PIC16F62X Silicon/Data Sheet Errata

The PIC16F62X (Rev. A) parts you have received conform functionally to the Device Data Sheet (DS40300B), except for the anomalies described below.

Clarifications/Corrections to the Data Sheet:

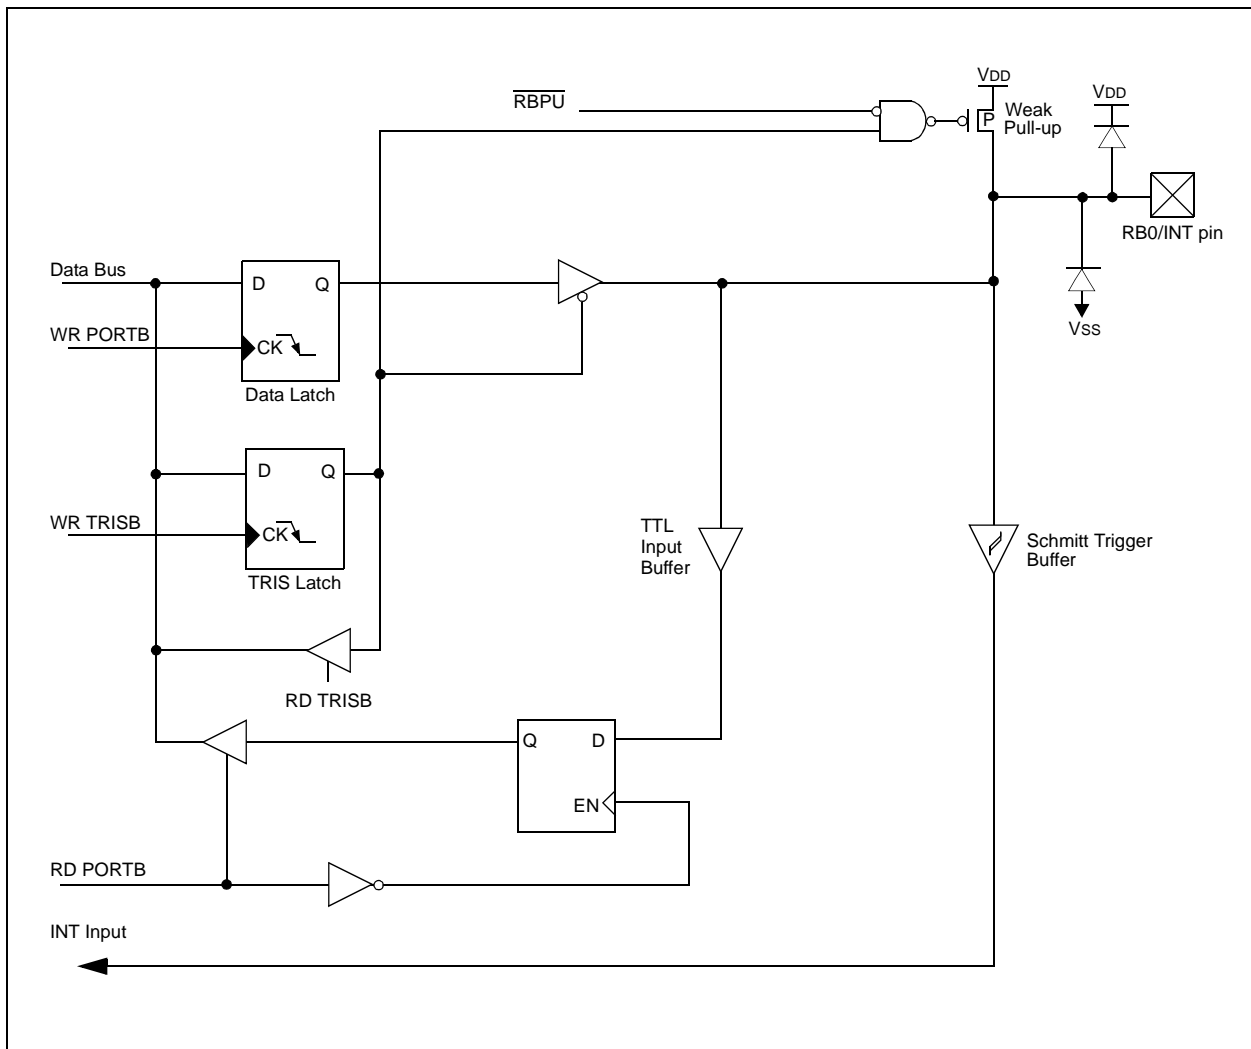
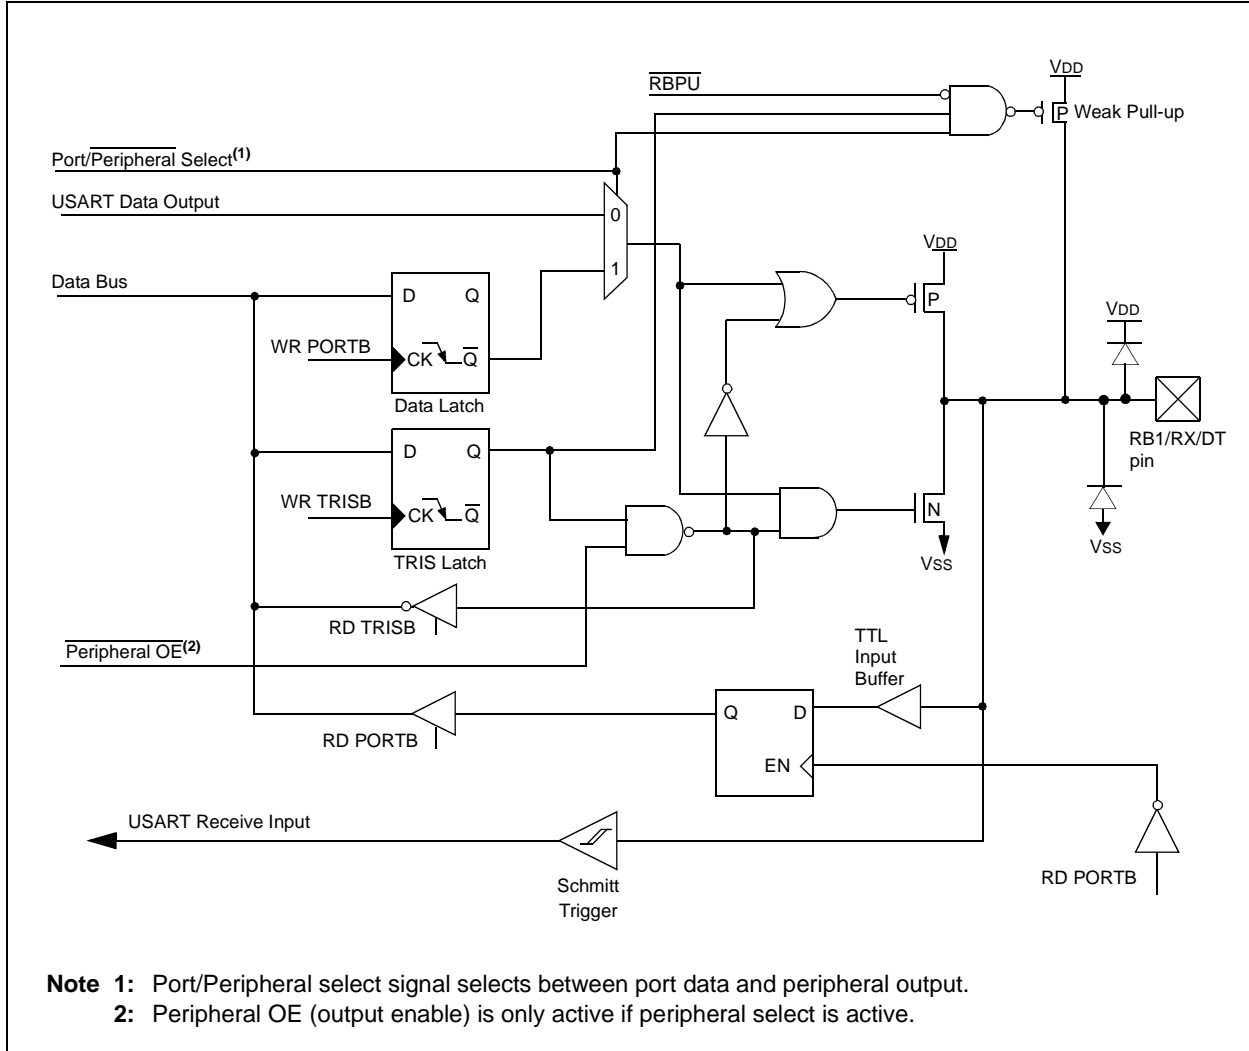
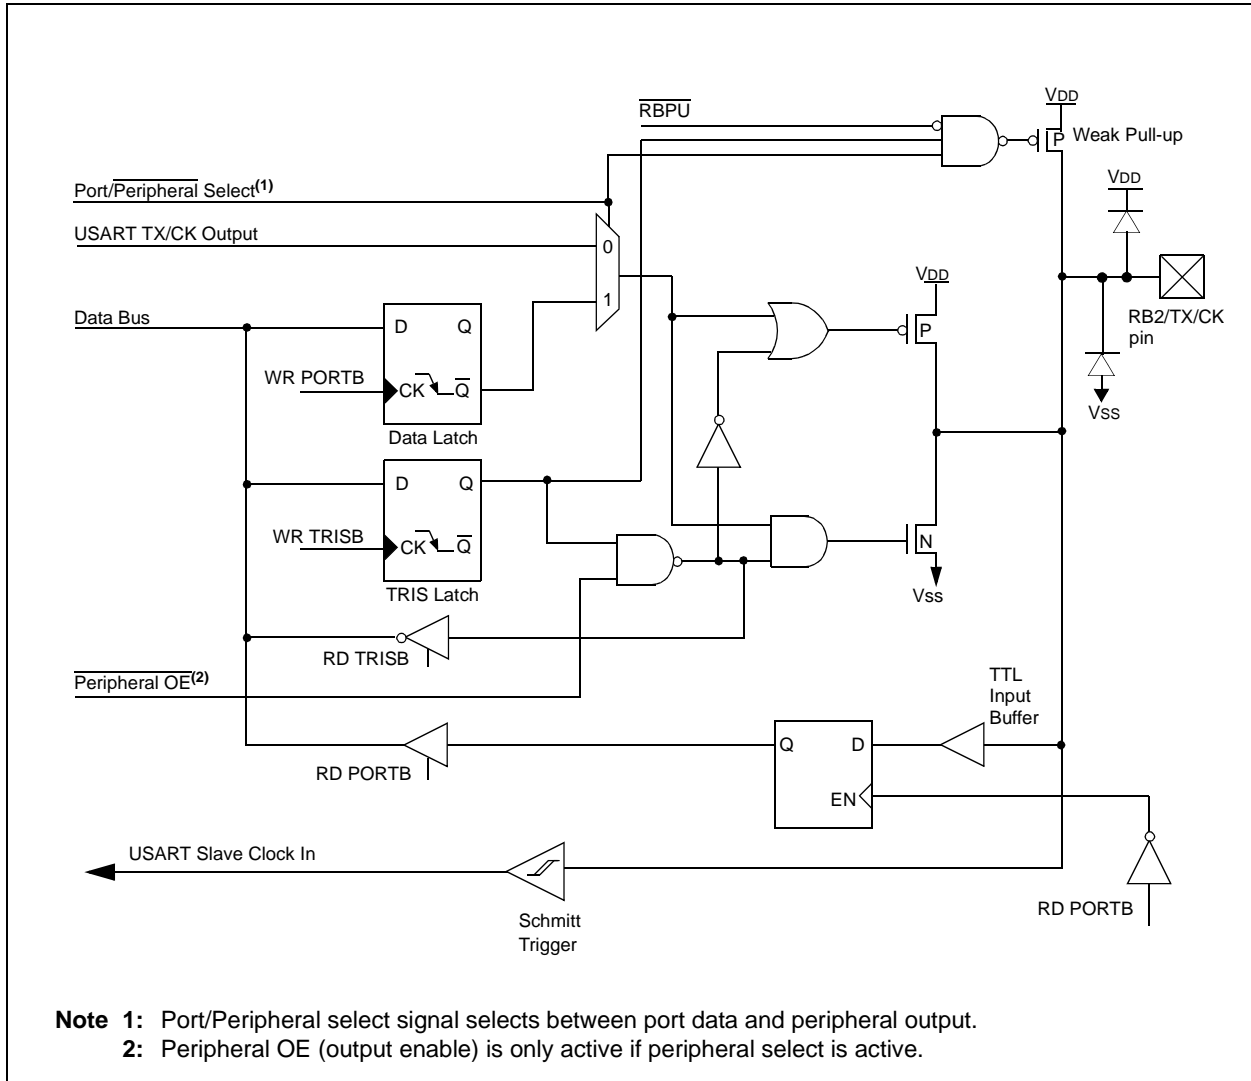
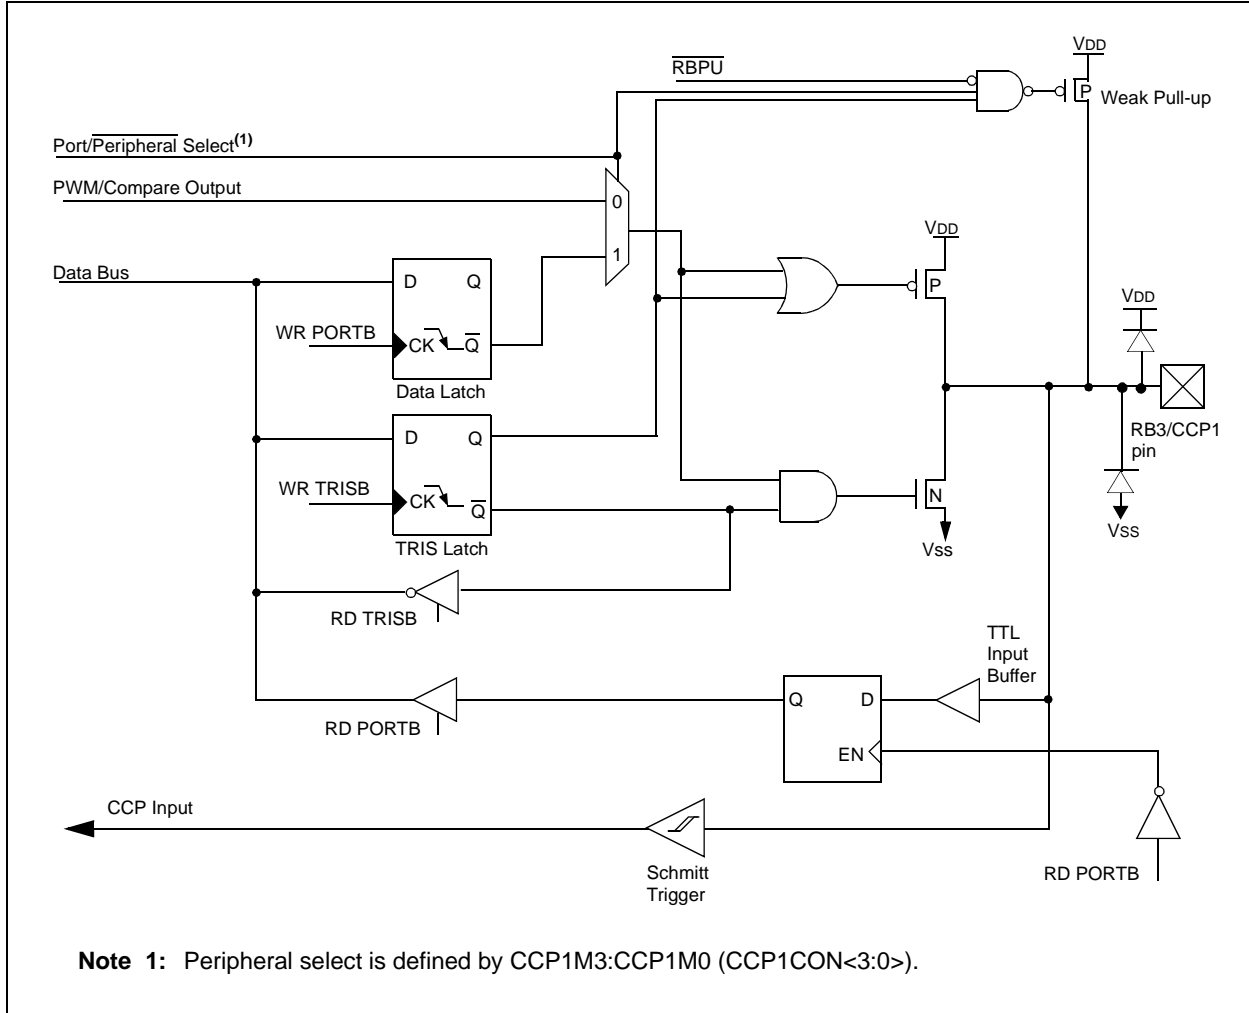
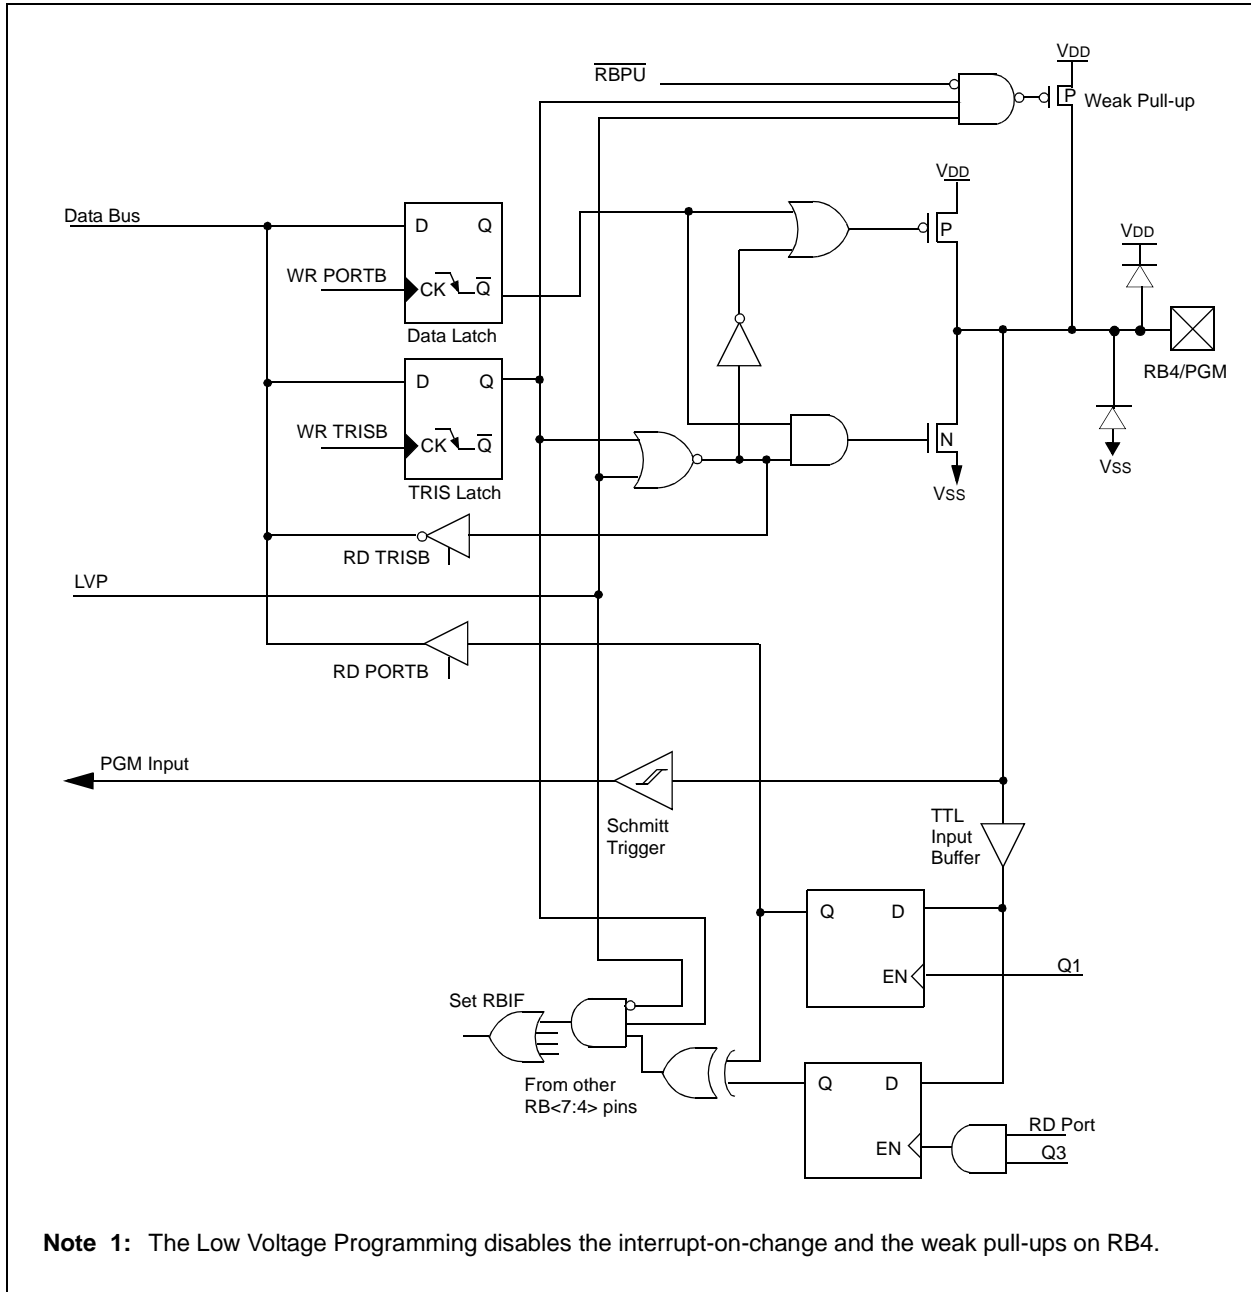
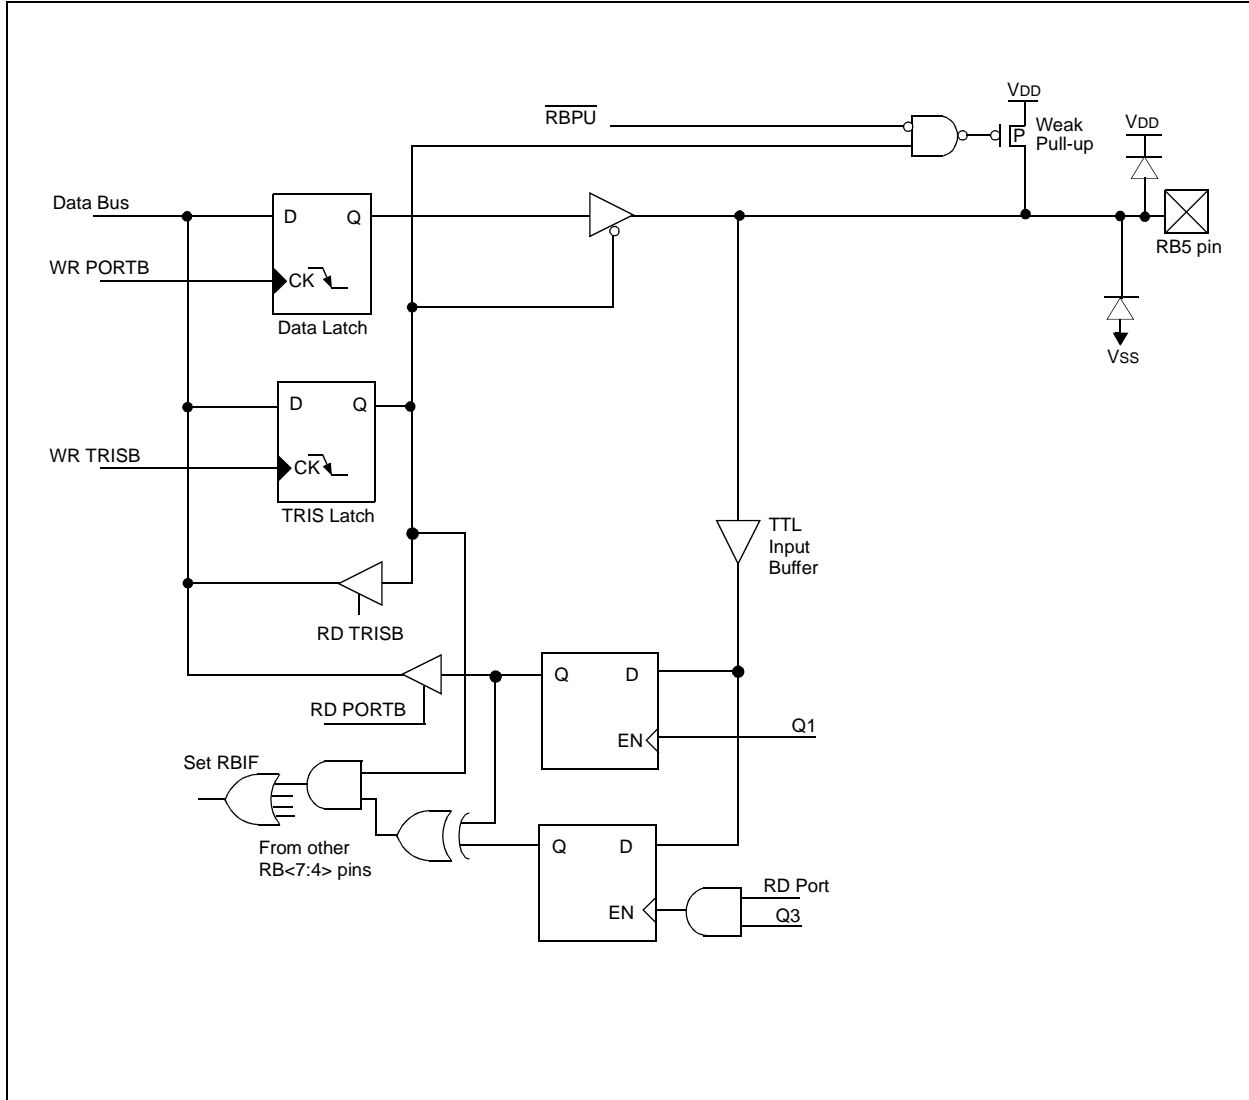
1. Module: I/O Ports

A read of the PORTB Data Direction Register (TRISB) returns the Data Direction state on the port pins themselves and not the contents of the TRISB register latch.
